PATENT APPLICATION

Applicant(s): Dieter ELSÄSSER et al.)
Serial No.: 07/653,100)
Filed: February 8, 1991)
For: DISK STORAGE DRIVE HAVING)
INTERNAL ELECTRICAL)
CONNECTION PASSAGE AND)
CONTAMINATION SEALS AT)
ENDS OF THE MOTOR)
Group Art Unit: 2303)
Examiner: A. Heinz)
Batch No.: C55)
Date of Notice)
of Allowance,)
PTOL-85: May 5, 1992)

TRANSMITTAL OF NEW DRAWINGS TO CORRECT
INFORMALITIES AFTER THREE-MONTH PERIOD OF RESPONSE
SET IN NOTICE OF ALLOWABILITY (PTOL-37)

FIG. 1

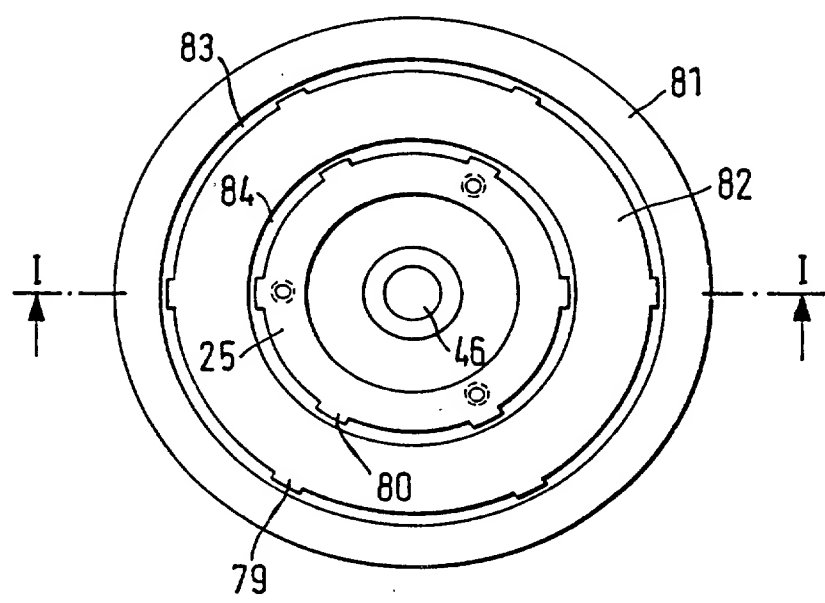
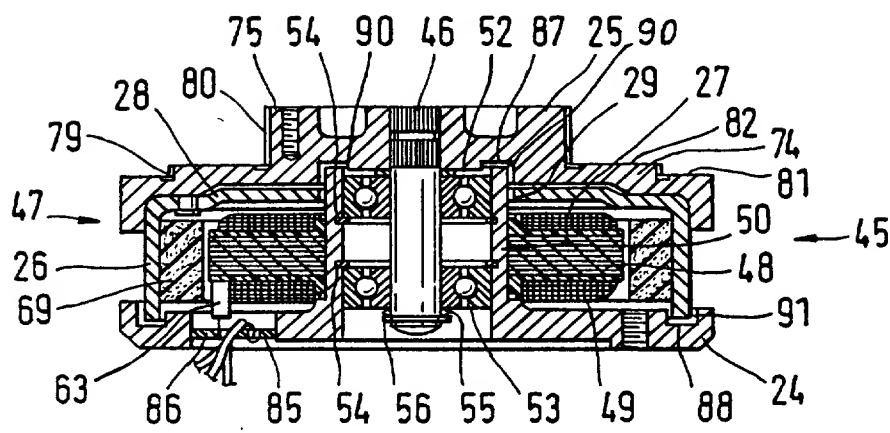
To correct the informalities in the drawings as noted in the draftsman's objections on PTO-948, Applicants submit herewith new drawings for this application. A complete set of ten (10) sheets are submitted. It is believed that all informalities have been corrected, with the exception of the draftsman's objection noted on Paragraph 4 of criss-cross hatching not being allowed in Figures 1 and 6-14.

It is respectfully requested that the official draftsman review this matter. According to M.P.E.P. §608.02, page 600-51, a copy of which is attached hereto as Exhibit A, the drawing symbol for wire, highlighted in yellow, is a criss-cross hatching. In all instances cited in these figures, the criss-cross is believed correctly applied because of the reference to coil(s) of wire, such as copper wire, on a laminated iron core. Accordingly, the new drawings included herewith continue to use the criss-cross hatching representation.
